**Title: STAGE 1 ROAD SAFETY AUDIT**

**R132 Connectivity Project.**

**Report reference: 0774R02 Rev 2**

**VERSION: FINAL (April 2021)**

Drawing 200021-DBFL-RD-ST-SK-C-1912 Rev P01

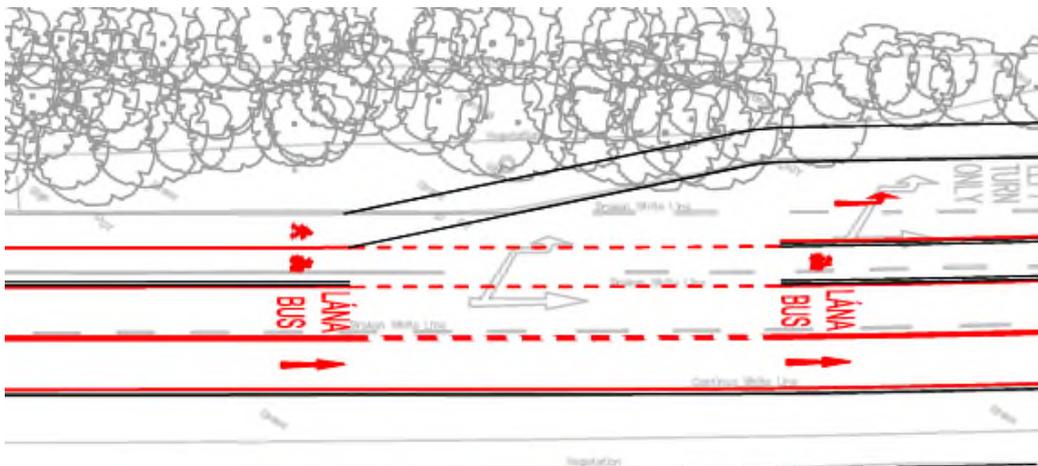
It is proposed that northbound diverging traffic into the Pavilions will cross the bus lane and the cycleway. This could lead to collisions with cyclists that may not been seen by turning drivers due to the presence of buses. This could lead to collisions with cyclists.

It is recommended that the cycleway is brought behind the diverge lane similar to the footway.

3.1.2	Y	Y		
3.1.3	Y	N	<p>Relocation of the cycleway to behind diverge lane will result in a longer diversion for cyclists and it is felt that cyclists will choose to remain on road in the Bus Lane. The relocation of the cycleway will also require crossing of the entry and exit lanes to/from Pavilions as well as potential for conflict with pedestrians crossing here.</p> <p>The opening for left turning vehicles crossing the cycleway has been reduced to limit potential exposure/conflict.</p> 	Yes

Drawing 200021-DBFL-RD-ST-SK-C-1913 Rev P01

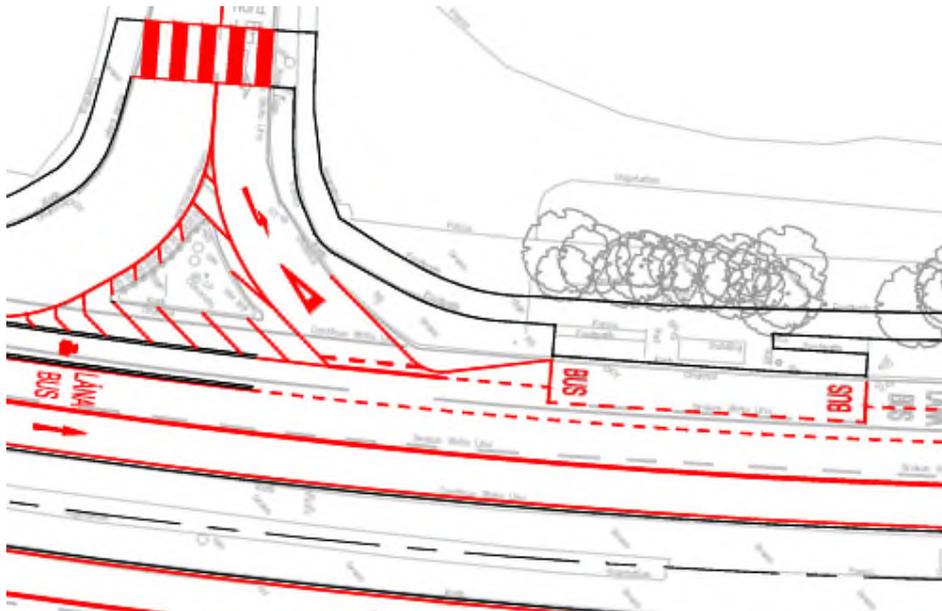
It is proposed to provide a bus stop immediately upstream of the left-out junction of the pavilions shopping centre. Drivers exiting the junction will have a significant amount to check before exiting including, cyclists, weaving and slowing buses and through traffic. There is a risk that during peak traffic periods that drivers will be tempted to accept smaller gaps than required leading to collisions. This may be compounded by the acute angle of the merge which may lead to some mobility impaired drivers not being able to properly see approaching cyclists and vehicles.

It is recommended that the Pavilions junction be signalised taking bus movements into account.

3.1.4	Y	N	It is proposed to signalize this junction in the medium term subject to the development of private lands on the eastern side of the R132.	Yes

Drawing 200021-DBFL-RD-ST-SK-C-1913 Rev P01

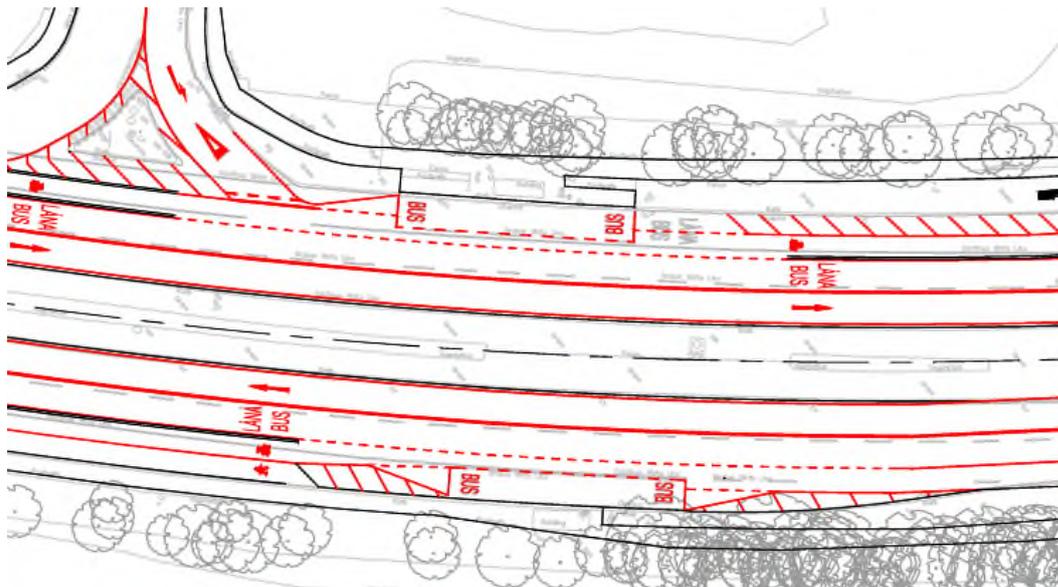
It is proposed to provide a bus stop on each side of the R132 adjacent to the Pavillions junction. There will be a desire line for bus users across the median as the signalised crossing will be deemed too far away to walk. This could lead to collisions between crossing pedestrians and through traffic.

It is recommended that the bus stops be relocated closer to the Malahide Road Junction, that a controlled pedestrian crossing of the R132 be provided or that the median fencing provision be increased to prevent pedestrian movements.

3.1.5	Y	Y	Bus stops will be relocated as part of the Metrolink works. In the meantime, fencing will be installed to prevent pedestrian movements between the stops.

Drawing 200021-DBFL-RD-ST-SK-C-1911 Rev P01

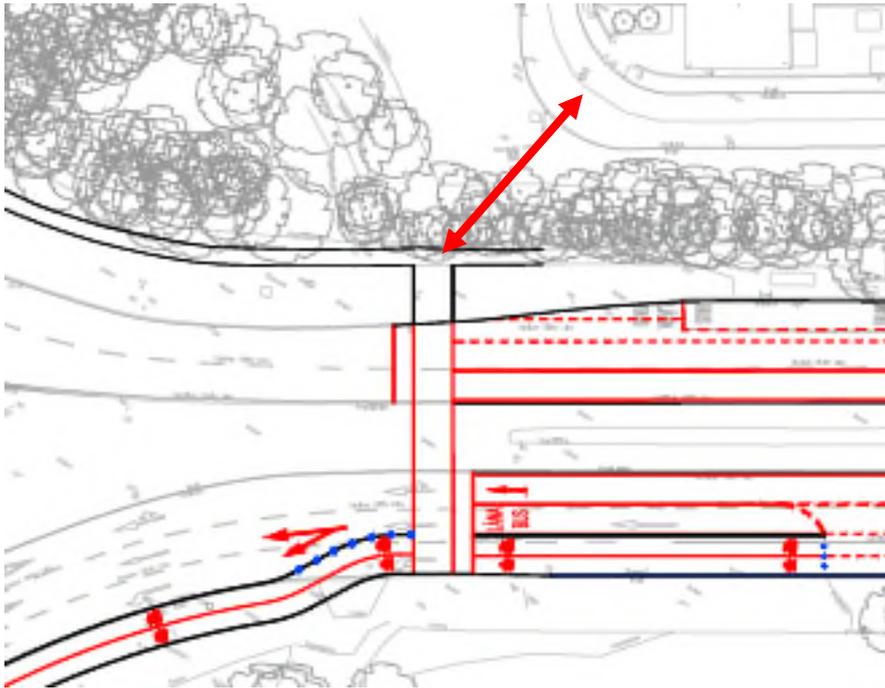
There is a pedestrian desire line from Carlton Court to the proposed Toucan Crossing close to the Pinnock Hill Junction. This is through an unpaved area with a steep section which could lead to slips and trips especially in wet conditions.

It is recommended that a pedestrian and cyclist link from Carlton Court be provided to the facilities on the R132.

3.1.6	Y	N	The formalization of this link is not proposed as part of the R132 Connectivity Scheme. FCC will be made aware of the issue and can consider as part of a future scheme if there is local interest.	Yes

Drawing 200021-DBFL-RD-ST-SK-C-1913 Rev P01

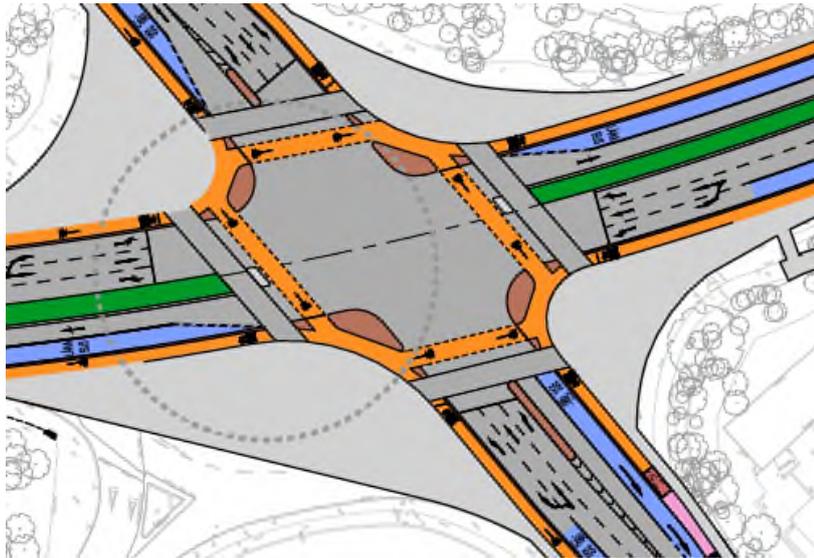
The junction is a skewed junction and it is unclear if the acute angles will enable left turning by all classes of vehicles. Without adequate space the trailing wheels of larger vehicles could overrun the cyclist protection islands causing material damage and possible collisions with cyclists.

It is recommended that a swept path analysis is carried out to ensure all planned vehicle movements can be readily accommodated.

3.2.1	N	Y	Swept path analysis drawings provided with this response.	Yes
3.2.2	Y	N	The scheme will now end with a Shared space crossing of Ashley Avenue. FCC will develop cyclist connections eastward as part of a future scheme connecting Swords & Malahide. See updated drawing	Yes

Drawing 200021-DBFL-RD-ST-SK-C-1913 Rev P01

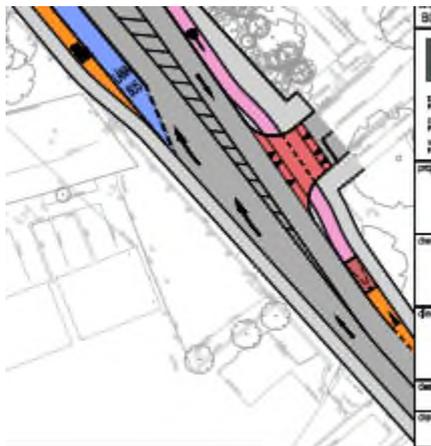
There is an existing on-street bus stop on the Malahide Road at or close to the proposed cycle lane taper. Pedestrians wishing to exit/enter the bus may have to cross a cycle lane which could lead to trips and falls due to the level difference or could lead to collisions with cyclists. In addition, cyclists may lose control if they try to transition from off-road to on-road upstream of a parked bus where there is a level difference between the cycle track and the carriageway.

It is recommended that the design includes the bus stop and suitable treatment for cyclists at that location.

Drawing 200021-DBFL-RD-ST-SK-C-1914 & 1915 Rev P01

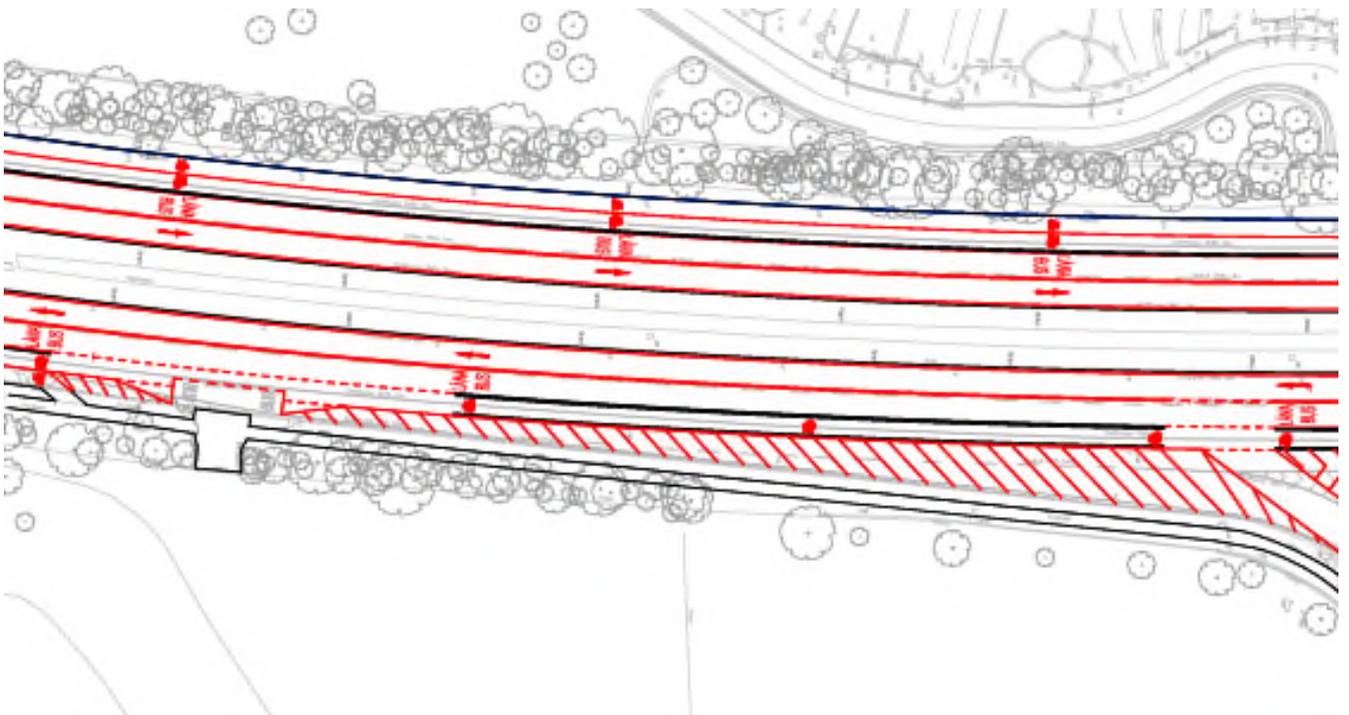
There is a large hatched area associated with the left-in left-out business park (Scheneker). There is a risk that the hatched road markings will become worn over time and the exit from the junction will not be clearly defined. This could lead to drivers using the hatched area as an acceleration lane. This could lead to higher speeds and possible collisions with cyclists.

It is recommended that the area where vehicles are not to travel is made clearer by providing hard standing, landscaping or bollards.

3.3.1	Y	Y		
3.3.2	Y	N	Relocation of the cycleway to behind diverge lane will result in a longer diversion for cyclists and it is felt that cyclists will choose to remain on road in the Bus Lane. The relocation of the cycleway will also require crossing of the entry and exit lanes to/from the industrial facility as well as potential for conflict with pedestrians crossing here.  The opening for left turning vehicles crossing the cycleway has been reduced to limit potential exposure/conflict.	Yes

Drawing 200021-DBFL-RD-ST-SK-C-1915 Rev P01

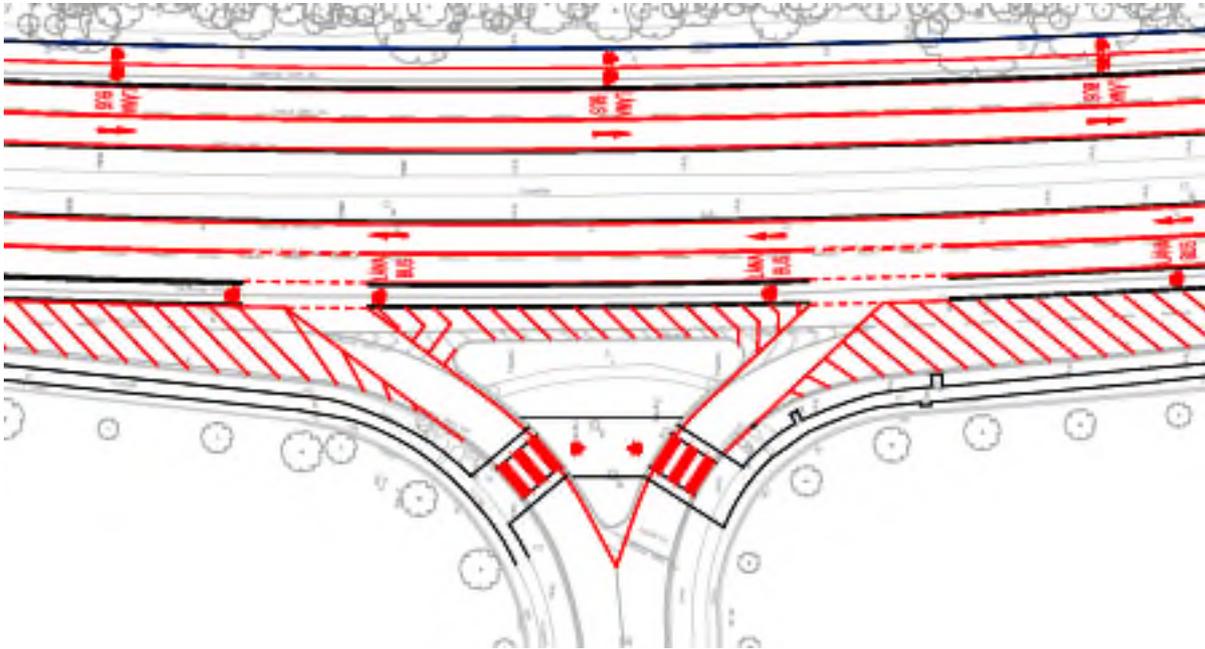
It is proposed that southbound diverging traffic into the business park will cross the bus lane and the cycleway. This could lead to collisions with cyclists that may not be seen by turning drivers due to the presence of buses.

It is recommended that the cycleway is brought behind the diverge lane similar to the footway.

Drawing 200021-DBFL-RD-ST-SK-C-1918 Rev P01

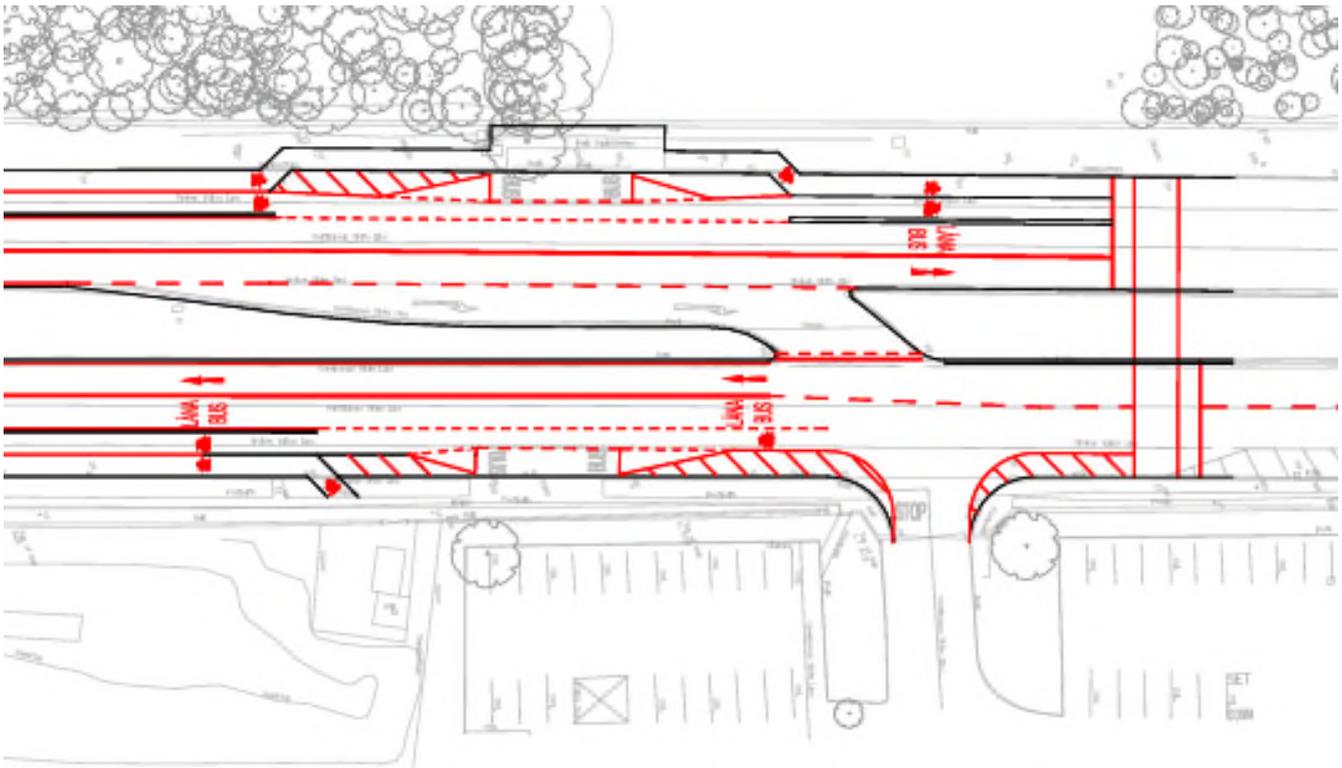
It is proposed to retain the right turning lane in the median at the Bostik industrial premises. It is proposed to provide a signalised pedestrian/toucan crossing immediately north of the right turn lane. There is a risk that right turning vehicles may start to turn when the signals are red for traffic to take advantage of the gap in the traffic. They may not complete the manoeuvre however and the traffic might start to flow in the southbound lane on the R132 and not expect conflicting turning traffic. This could lead to head-on collisions or rear end collisions if drivers have to stop suddenly after starting at the signals.

It is recommended that the right turning lane be incorporated into the signals.

3.4.1	Y	Y	Yellow box to be provided to prevent blocking of Seatown Road. Hatched areas will be defined with additional kerbing.	
3.5.1	Y	Y	This junction will be fully signalised to facilitate all movements including U-turns on the R132. See enclosed drawing.

Drawing 200021-DBFL-RD-SP-DR-C-1013 Rev P01

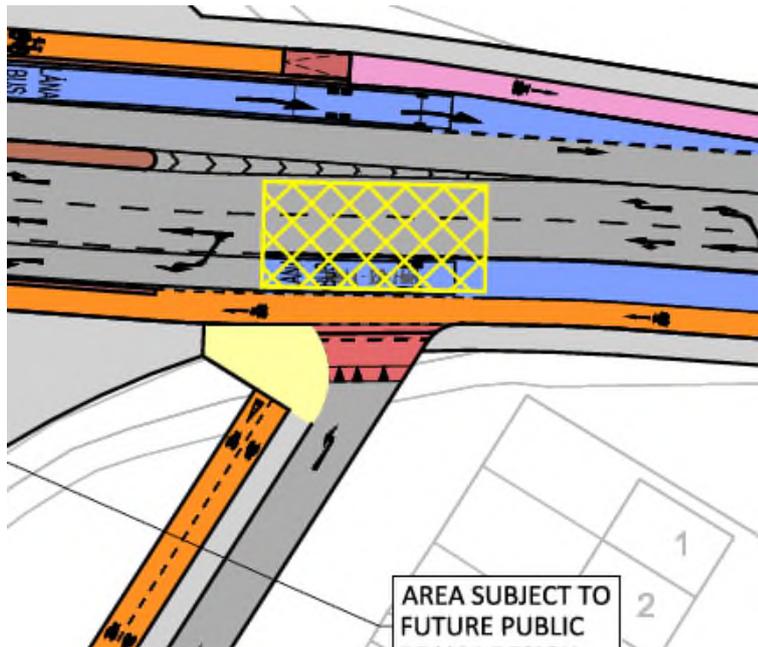
There is a risk that some drivers may turn right at the R106 to use the proposed link as a 'rat run'. This may lead to crossing of 4 lanes including the bus lane. The demand for such a movement may however be low since there are nearby alternative routes for Drynam Road traffic to travel eastbound on the R106.

It is recommended that if there could be a demand for drivers to turn right, that the splitter island on the R106 be extended to beyond the kink to physically prevent right turn movements.

3.6.1	Y	Y		
3.6.2	Y	N	Westbound cyclists will be permitted to use the emergency access route connecting the southbound cycle lane on the R132 to Drynam Road. This will reduce the potential for conflict with pedestrians on the south western corner of the Malahide Road junction which would be difficult to achieve if a 2 way cycle track was introduced.	Yes

Drawing 200021-DBFL-RD-SP-DR-C-1013 Rev P01

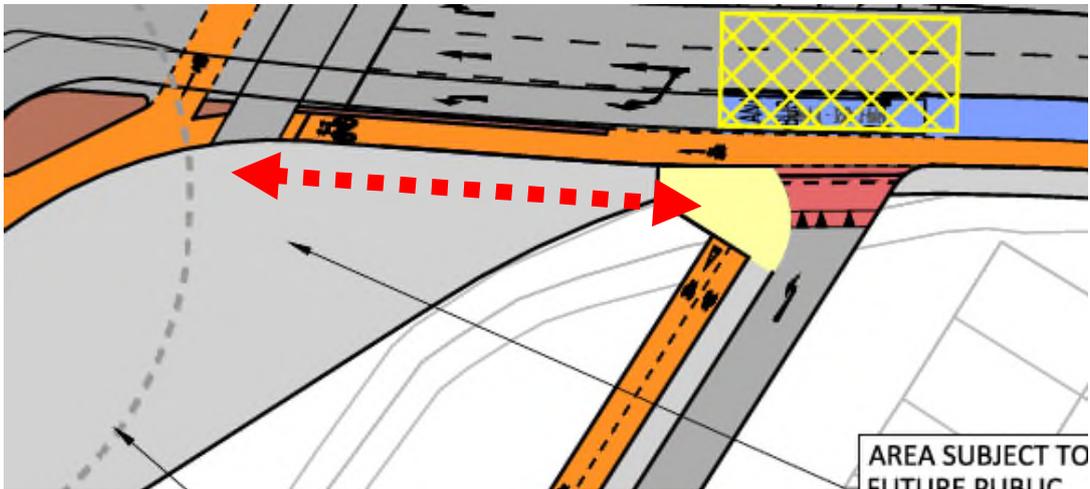
It is proposed to provide a two way cycle track along the Drynam Road link. There is however only a one way cycle track from the main signalised junction to the proposed link. This could lead to cyclists travelling contra flow along the R106 section.

It is recommended that a section of two way cycle track be provided from the junction to the link.

Drawing 200021-DBFL-RD-SP-DR-C-1013 Rev P01

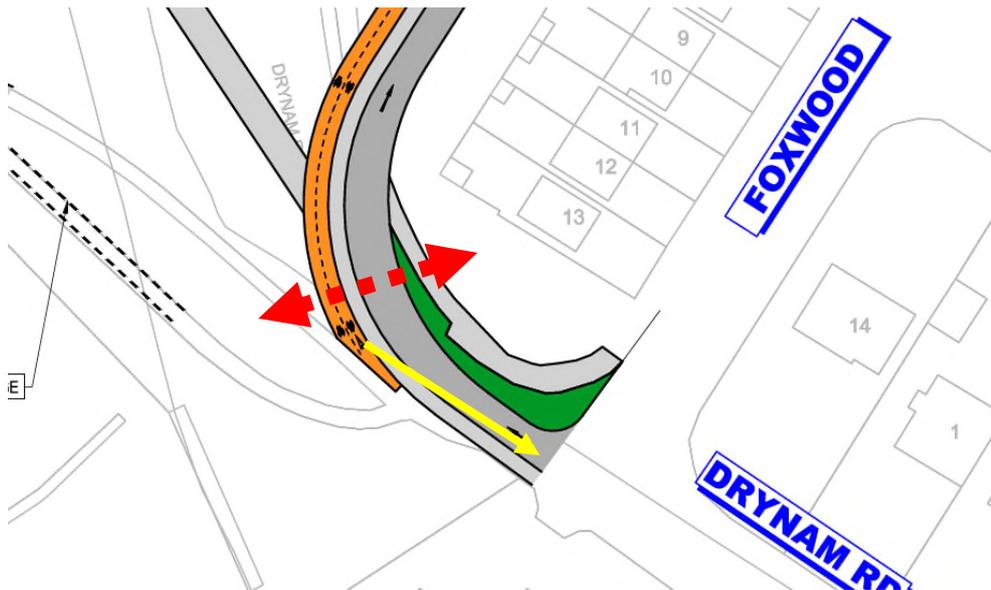
There is an existing controlled crossing of Drynam Road adjacent to the Foxwood residential area. Such a crossing is not shown on the proposed link. There is a number of footpaths that are not connected and the westbound cyclists would have to travel contraflow on a short section of the one-way Drynam Road Link.

It is recommended that the layout be reconfigured to have suitable crossing area for cyclists and pedestrians and without the need for cyclists to travel in a contraflow direction to vehicular traffic after the dedicated cycle facility terminates.

3.6.3	Y	Y	The existing crossing will be upgraded to a toucan crossing to bring westbound cyclists safely across the one way section of Drynam Road.	
3.6.4	N	N	Bus routes are to be moved from Drynam Road to Malahide Road under the BusConnects network redesign	Yes

Drawing 200021-DBFL-RD-SP-SK-C-1082 Rev P0

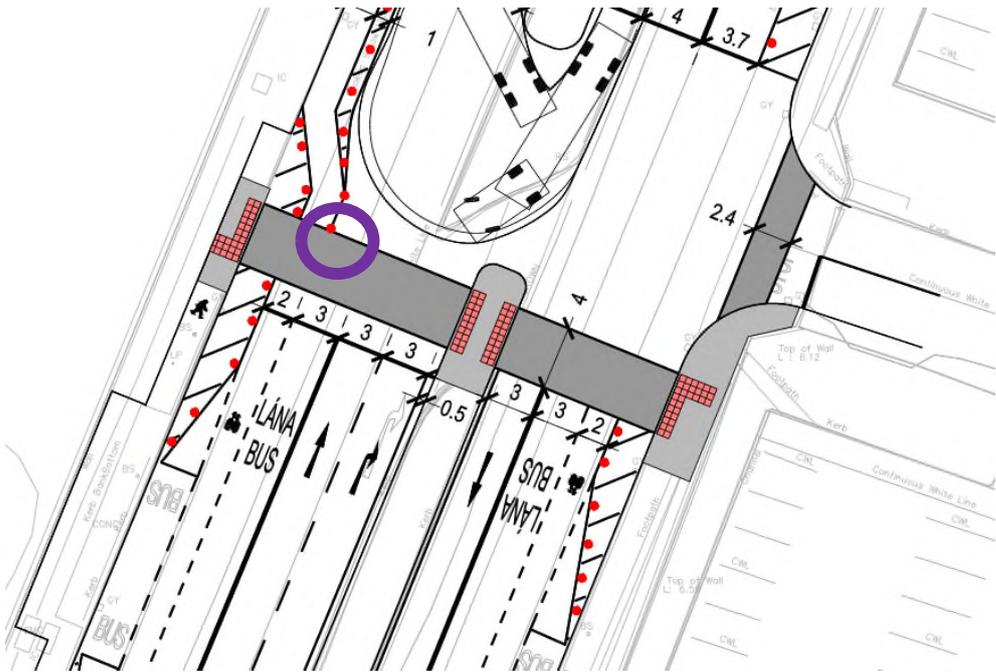
There is a risk that the flexible bollard at outside of the cycle lane north of the toucan crossing will be struck by passing buses. This could lead to a lack of guidance for future cyclists.

It is recommended that the cycle lane be tapered to the left to the kerb after the bus stop and prior to the toucan crossing and that the buffer zone between the cycle lane and bus lane be hatched.

3.6.5	Y	N	The realignment of the cycle track to the kerb side is difficult to achieve within the space available. The	Yes

Paragraph No. in Safety Audit Report	Problem accepted (yes/no)	Recommended measure accepted (yes/no)	Alternative measures (describe)	Alternative measures accepted by Auditors (Yes/No)
			<p>footpath/pedestrian waiting area has been extended eastwards to provide further definition for the northbound bus movement while one of the bollards has been removed immediately north of the toucan crossing. A reflective/keep left bollard will be used to further reduce the potential for buses colliding with the bollards. Red surfacing of the cycle track could also be used to serve the same purpose.</p>
